Supplementary Agenda Advice

Page 38 MC/19/0336 Gibraltar Farm Ham Lane, Hempstead

Correspondence from the Applicant's Agent (officer response below)

Figure 12 PCL for Crossing Arm & Space to Pass on Island

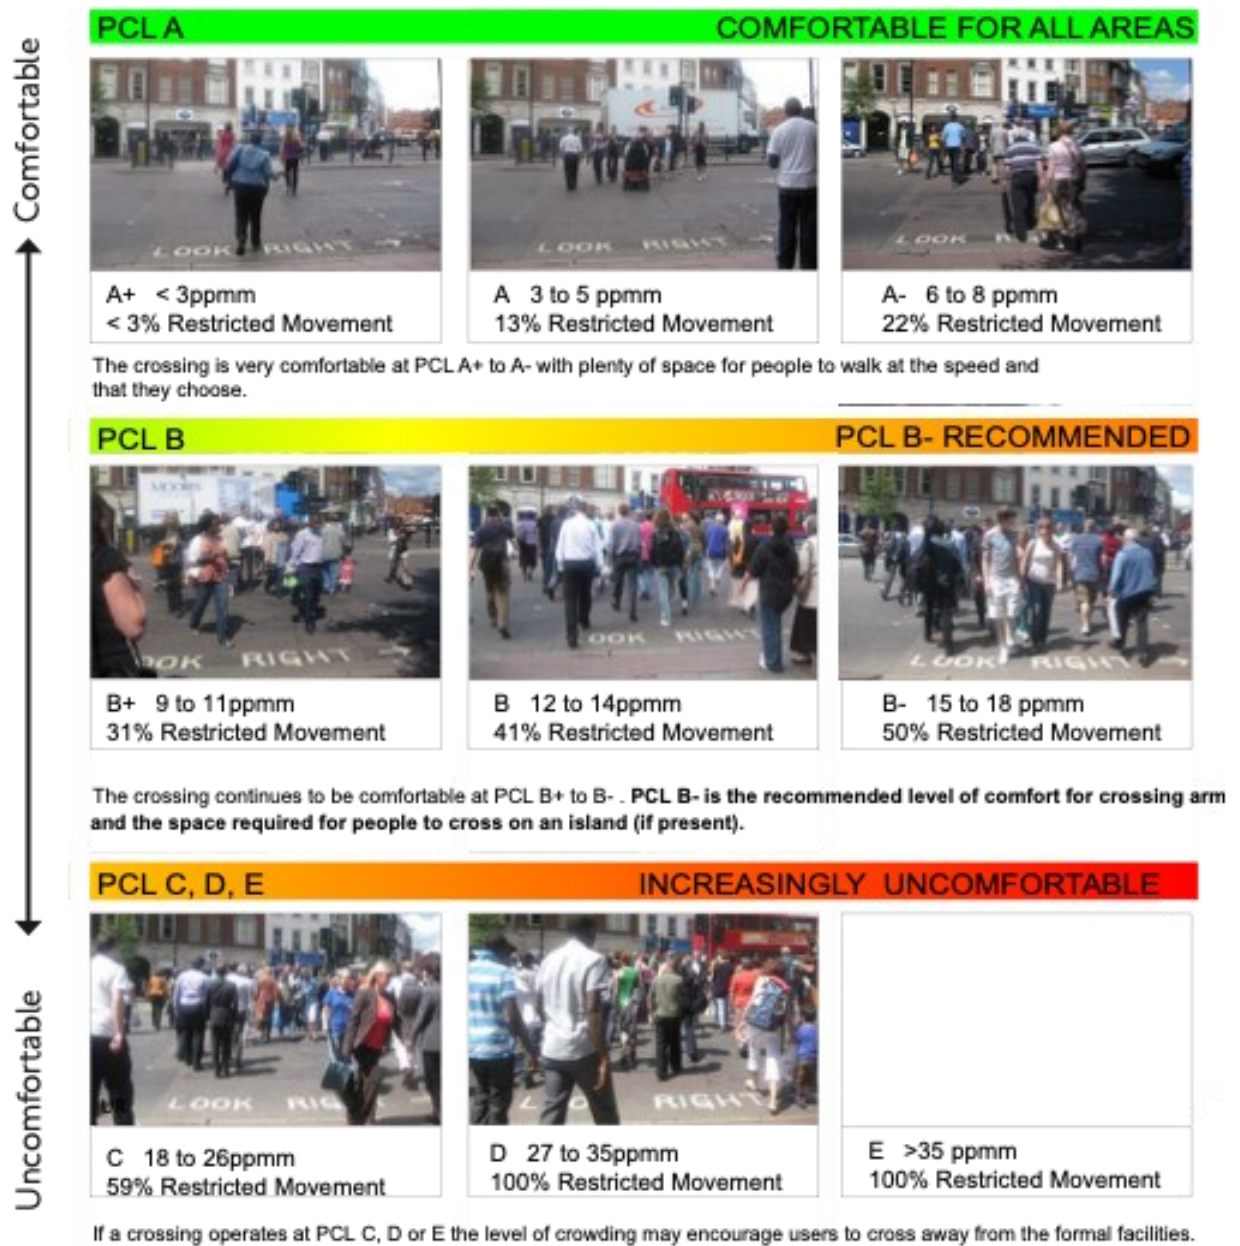
It is important to note that the levels of demand generation are comparably limited and the proposed byway upgrade would be more than adequate to accommodate this demand. The change, from an hourly peak of 36 to 87 movements, does not give rise to any specific increase in required parameters of the route, other than those already proposed. Outside of very congested urban environments, such as city centres or in the vicinity of major transport interchanges, it is rare for the physical capacity of pedestrian routes to be a determining factor. However, to assist we have examined the Transport for London guidance. This provides guidance on 'Pedestrian Comfort Level' related to the width of a pedestrian space. Here it can be seen that in our worst case scenario, we have 87 users per hour on a path with a minimum width of 3m. That equates, in PCL terms, to less than 0.5 ppmm (pedestrians per minute per metre width). This places it well within the very top level of comfort, or A+, which includes pedestrian environments. Demand on the byway would need to be 16 times higher (at around 1600 movements in the peak hour) than the level generated by the development to even fall outside of PCL A rating. To be considered less than recommended minimum width, the demand would need to be 35 times higher or over 3000 movements per hour. Below is an extract from the TfL guidance which we believe gives some further perspective.

Our transport consultants have concluded that there are no technical differences between the intended function of the byway upgrade for the extant or proposed schemes.

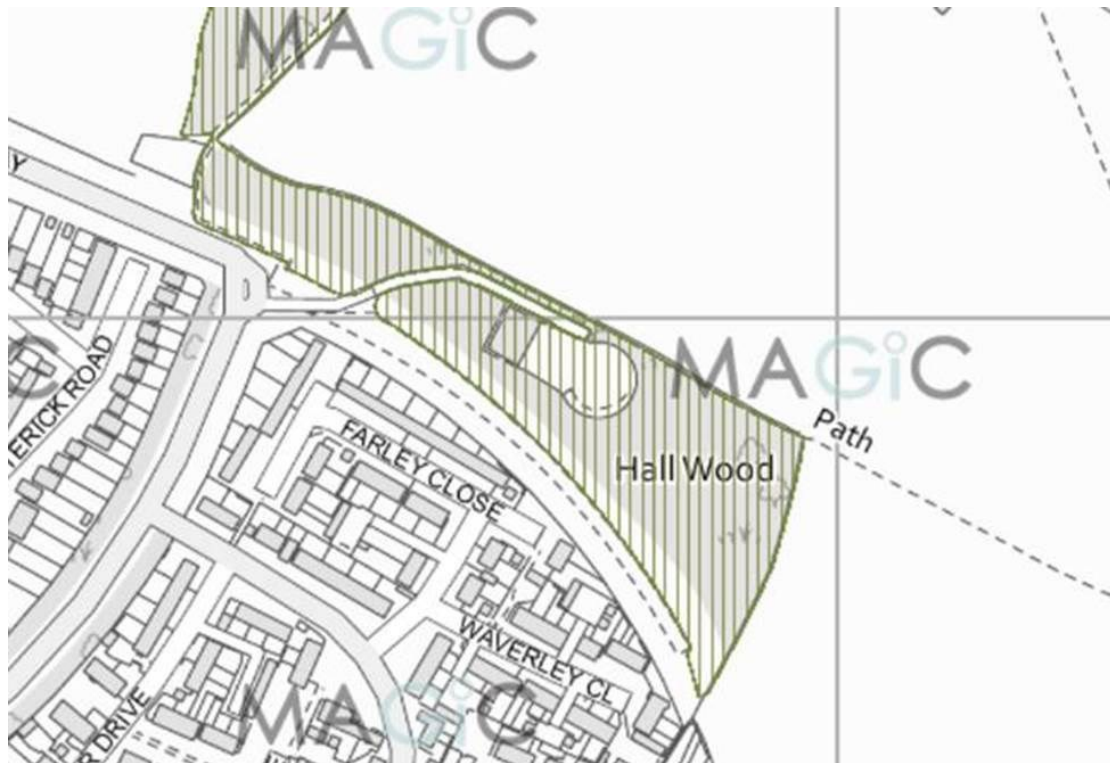
The Agent also writes that “the proposed minor widening is on the highway channel side not the Ancient Woodland side and therefore does not involve any excavation closer to the Ancient Woodland than the existing cycleway/route way which is already fully constructed.”

However, the DEFRA magic map shows that the byway itself and the highway verge to North Dane Way are within the designation of ‘Ancient Woodland’. (Shown hatched on the plan below.)

Ancient Woodland designations are not only designated as such due to the trees but also the value of the ancient soil and terrestrial ecosystems, rhizomes, nutrients etc.
